CITY PROJECT # 07-24

PALM SPRINGS ANIMAL CARE FACILITY

ADDENDUM NO. 1

Sketch Number
A1-S9

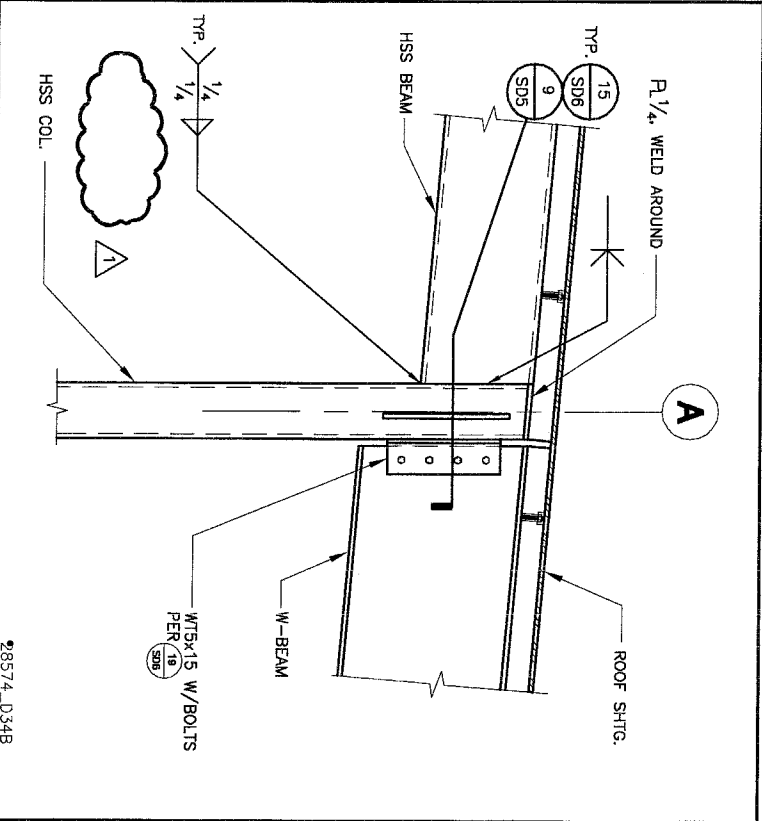
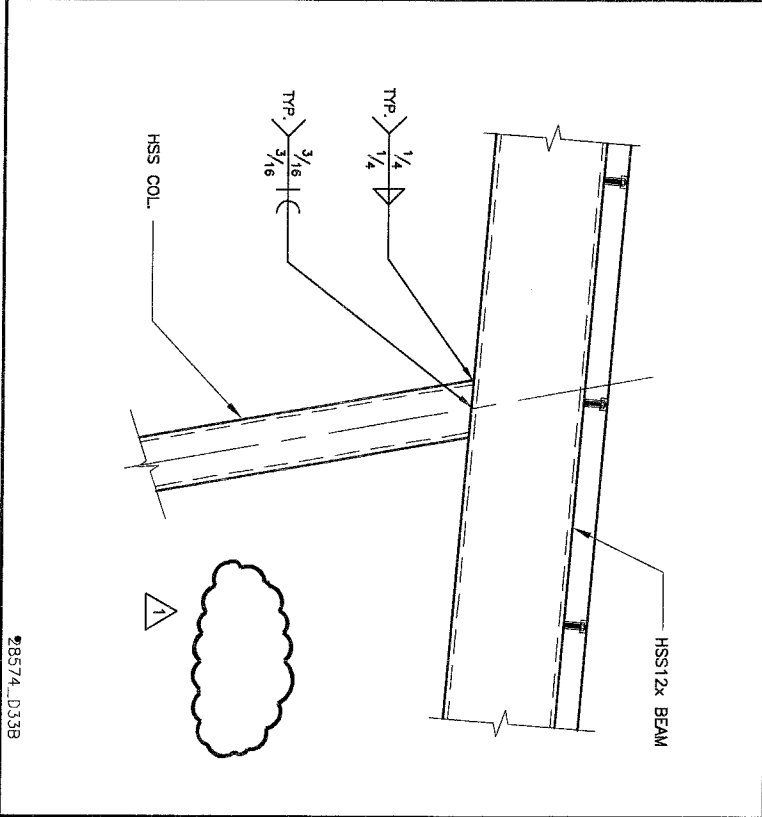
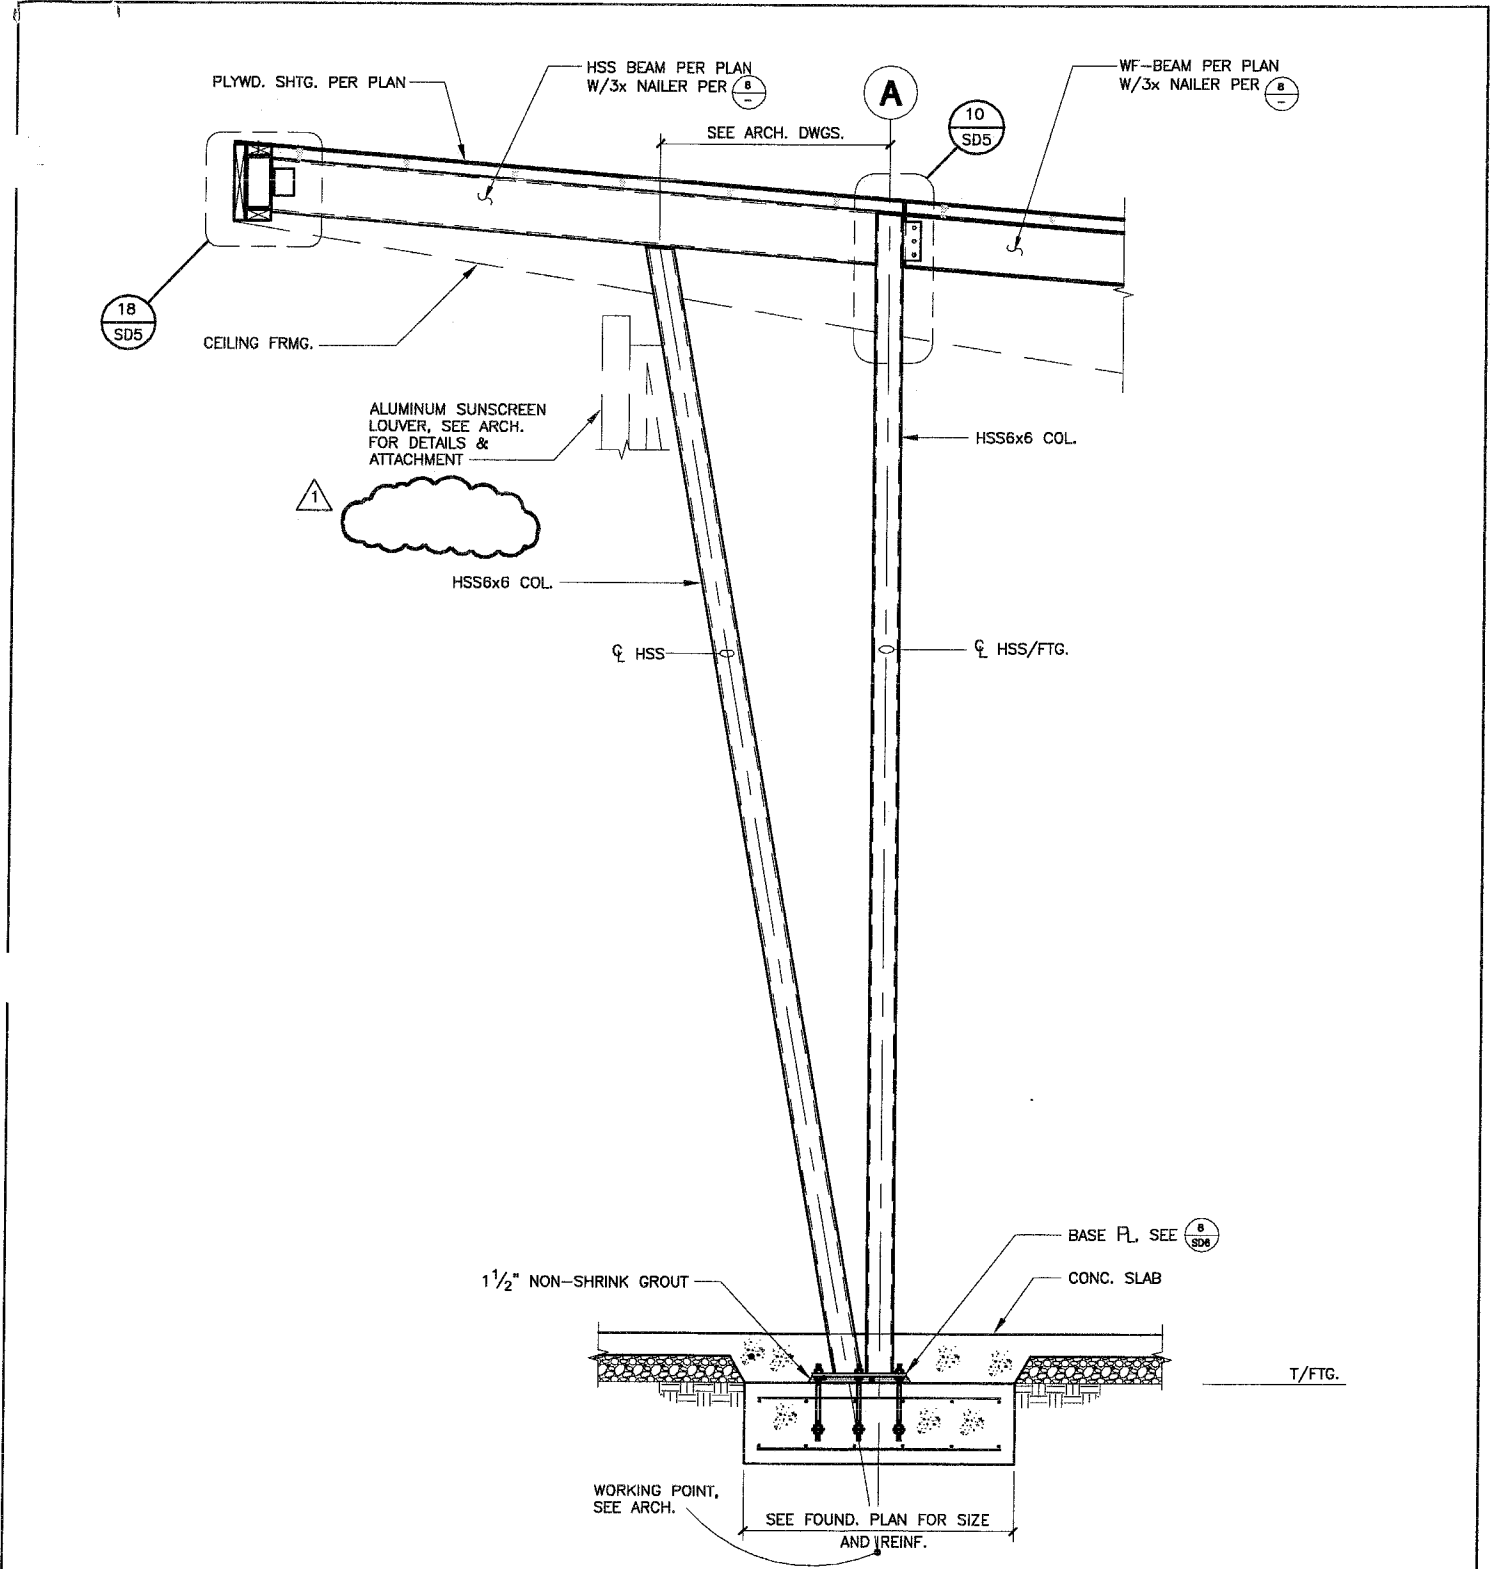
14. **A1-S8:** Revision to Drawing Sheet SD4 – Bearing at lower roof joist revised.
15. **A1-S9:** Revision to Drawing Sheet SD5 – Steel plate between columns removed.

16. **A1-S10:** Revision to Drawing Sheet SD5 – Steel plate between columns removed.
17. **A1-S11:** Revision to Drawing Sheet S4A – Wall at gridline D revised to 6" bearing wall. Detail 15/SD4 call out at gridline D between 14 and 14.4. Strap at line E has been added.

Reference Number
Sketch Number
A1-S12

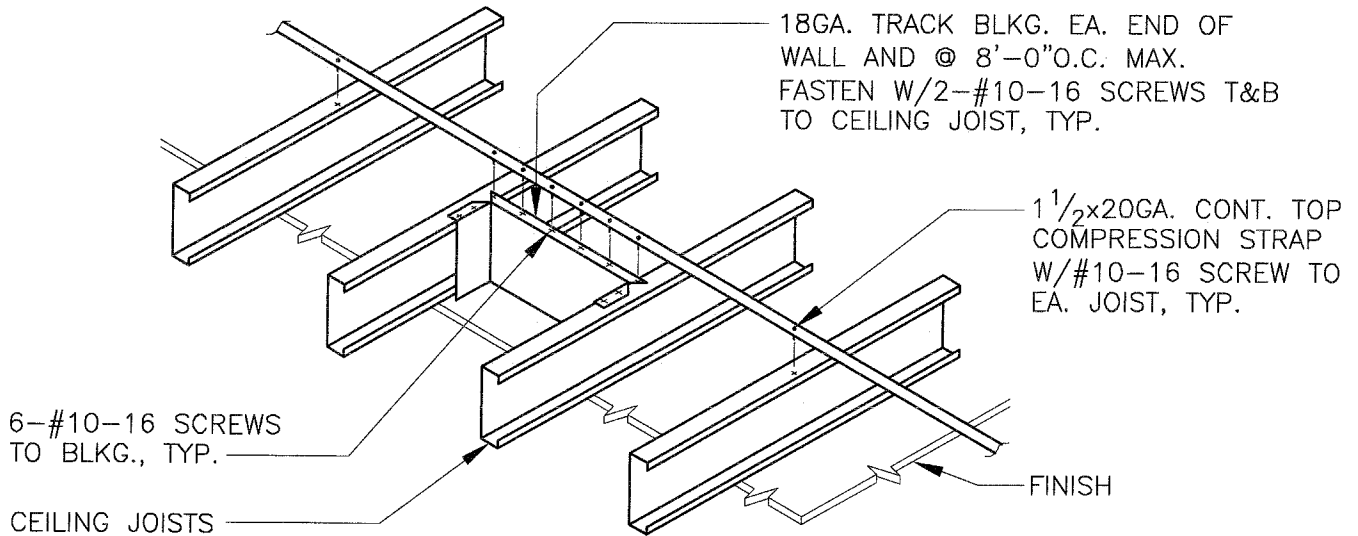
18. **A1-S12:** Revision to Drawing Sheet S3 – Connector references updated to match 17/SD7.
19. **A1-S13:** Revision to Drawing Sheet SD7 – CJ9 added.
20. **A1-S14:** Revision to Drawing Sheet SD7 – Note #1 added.

A1-S15

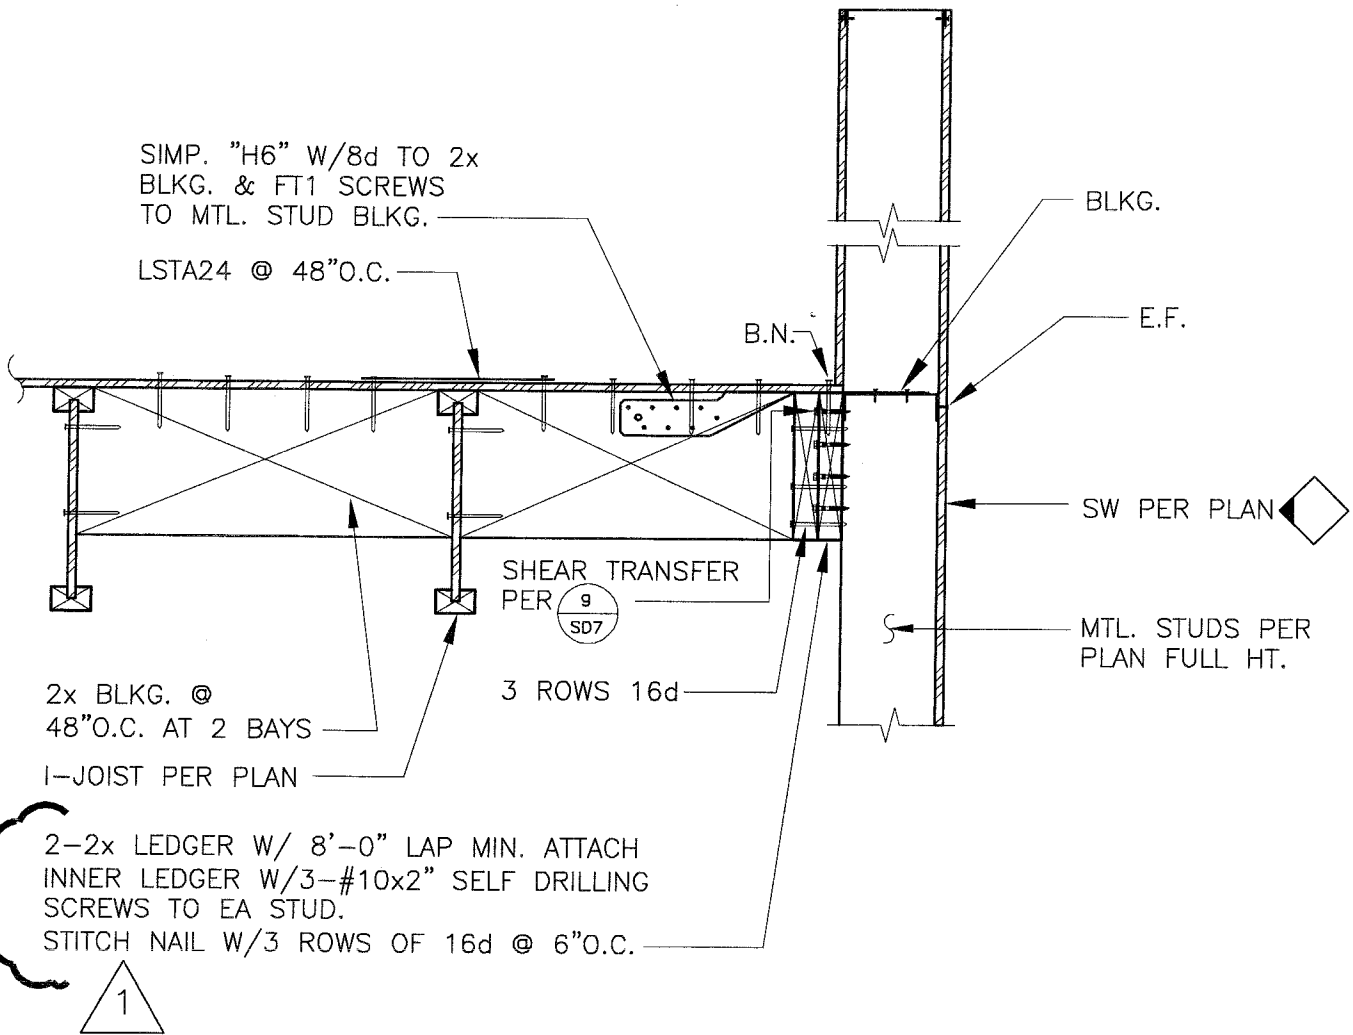
21. **A1-S15:** Revision to Drawing Sheet SD4 – Shear transfer detail reference revised.
22. **A1-S16:** Revision to Drawing Sheet S2A – Wall along D from Grid 5.5 to grid 17 revised to 6" bearing wall. Strip footing at wall added.

KSP KSP CONSULTING ENGINEERS, INC.	Date 01/27/10		Subject ADDENDUM - NO. 1		Reference Number
	Scale N.T.S.		Project Name and Number PALM SPRINGS ANIMAL CARE FACILITY		Sketch Number
	By JH/EA	Drawing Reference S3	File Name		A1-S17

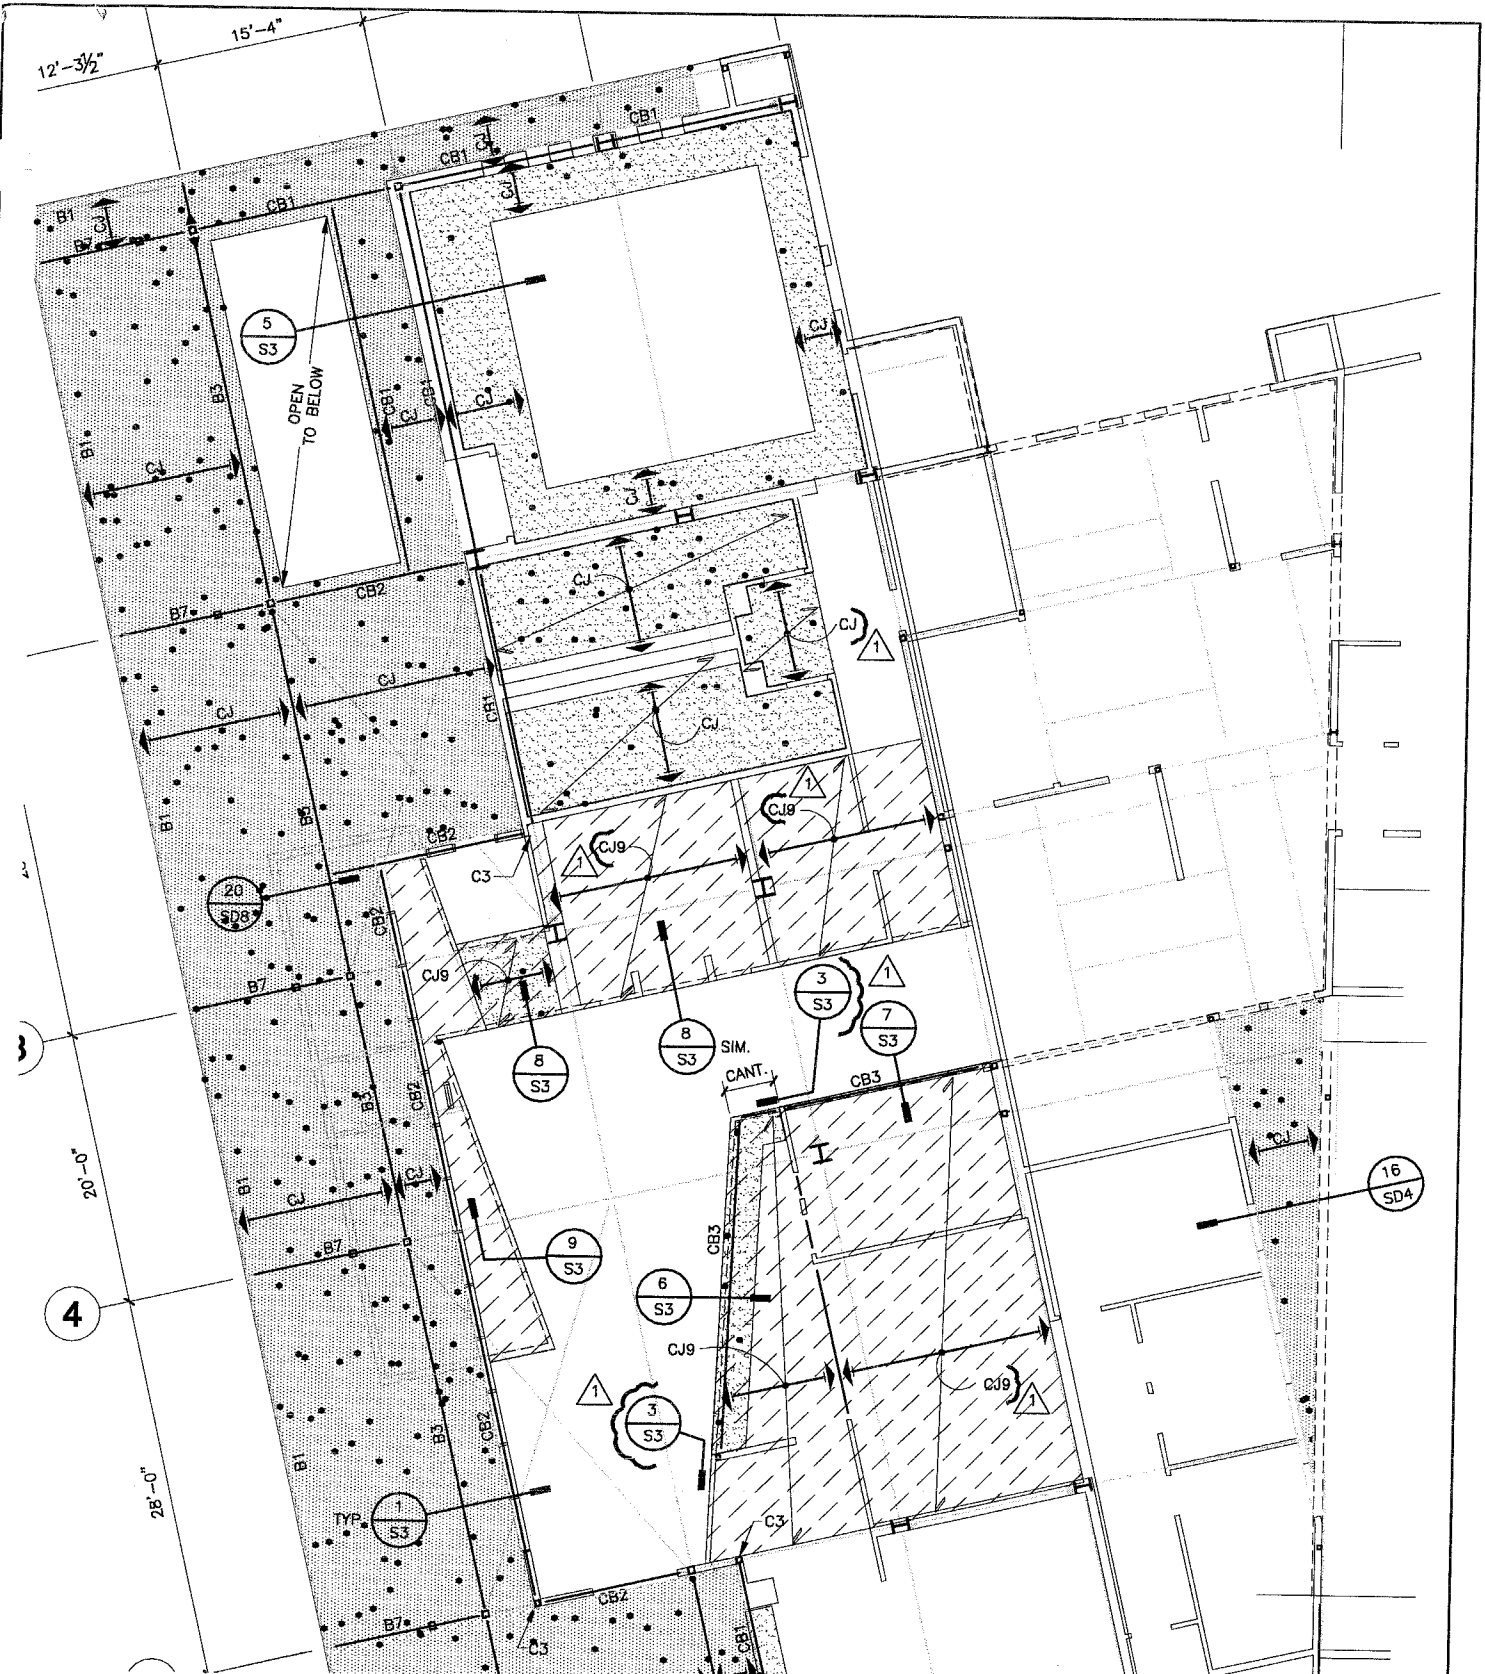
23. **A1-S17:** Revision to Drawing Sheet S3 – CJ9 Ceiling joists reference added.

A1-S18

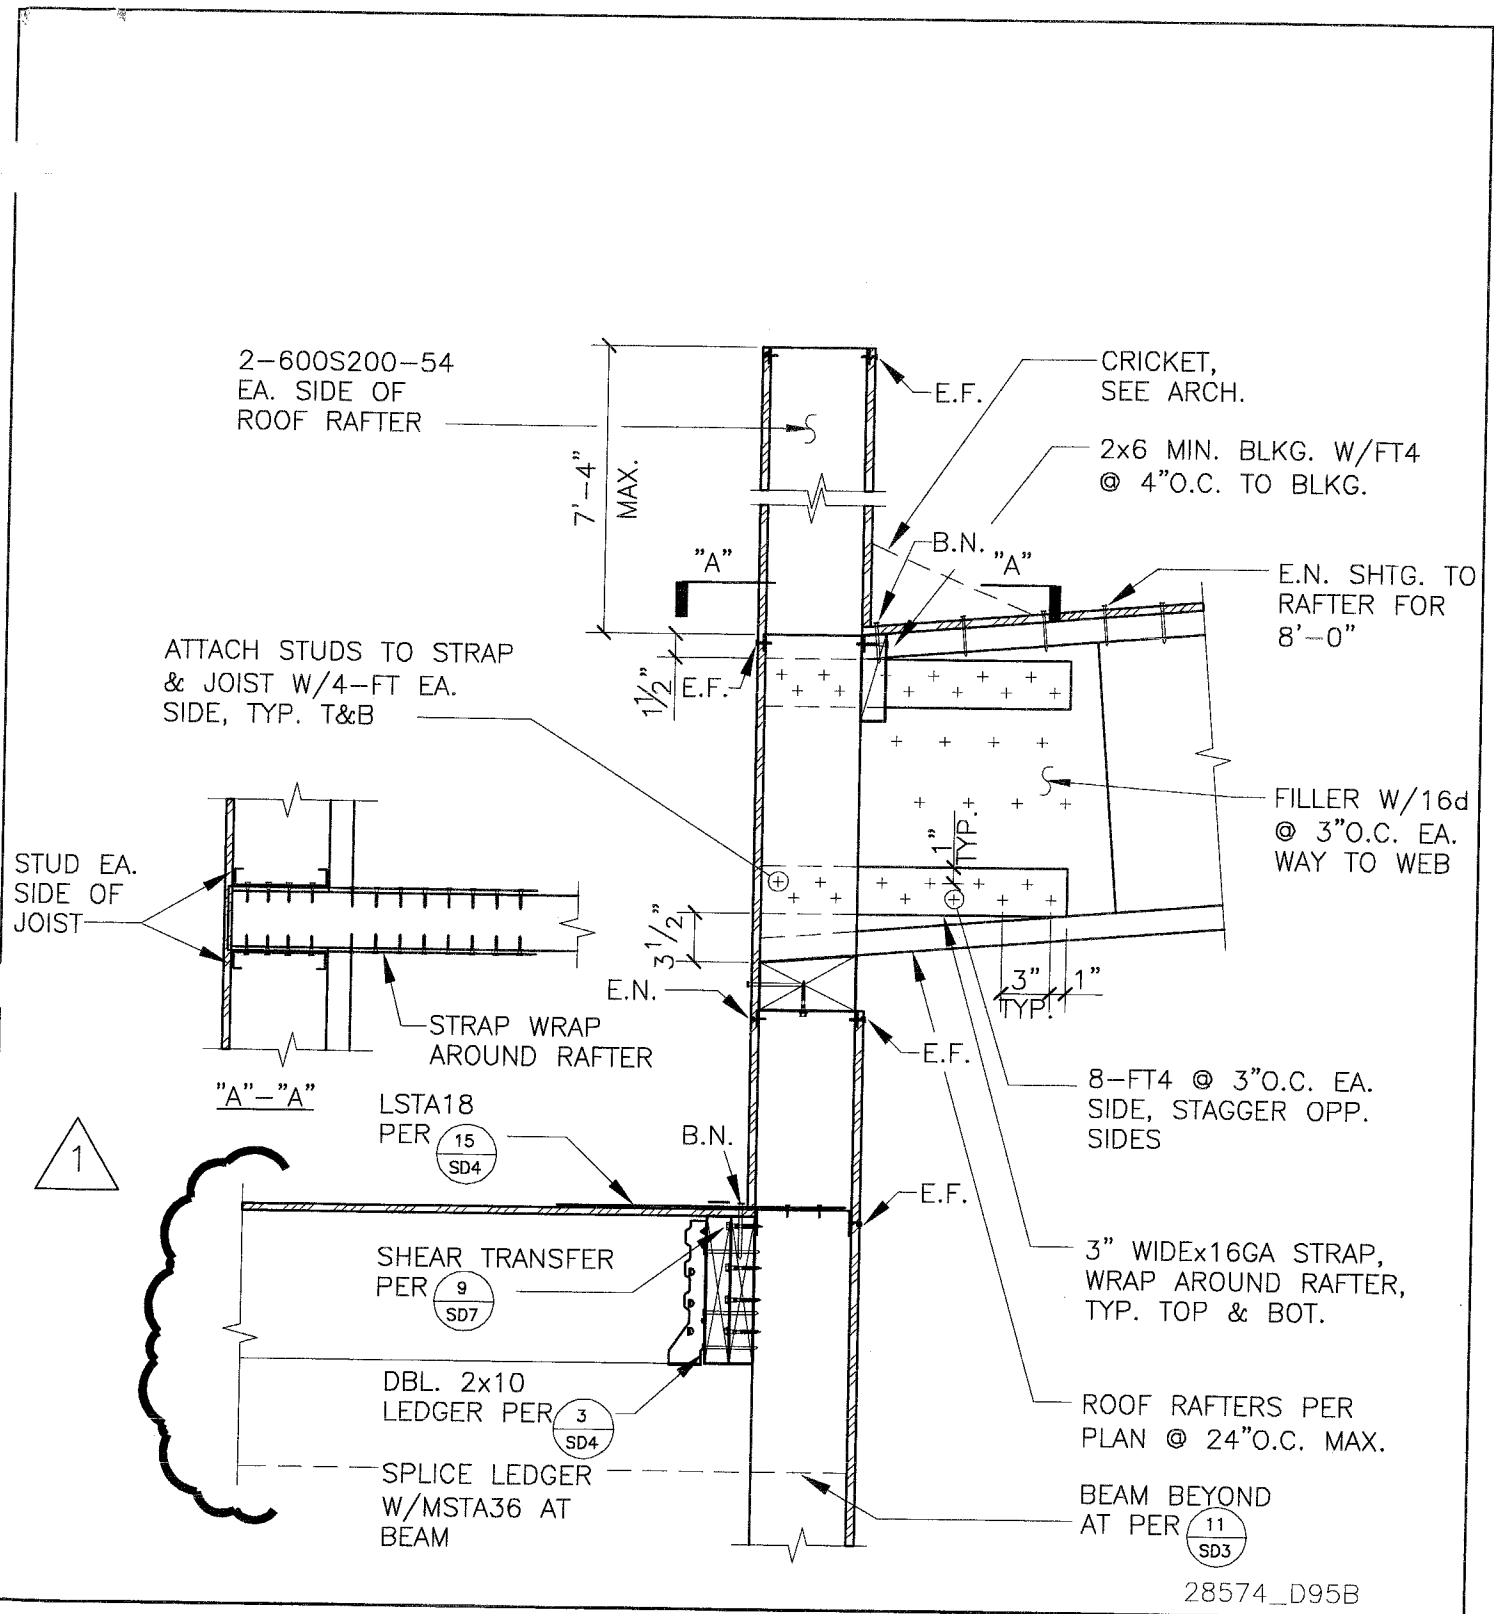
24. **A1-S18:** Revision to Drawing Sheet SD4 – Steel ledger replaced by wood ledger.
25. **A1-S19:** Revision to Drawing Sheet SD4 – lower roof framing shown perpendicular to wall.
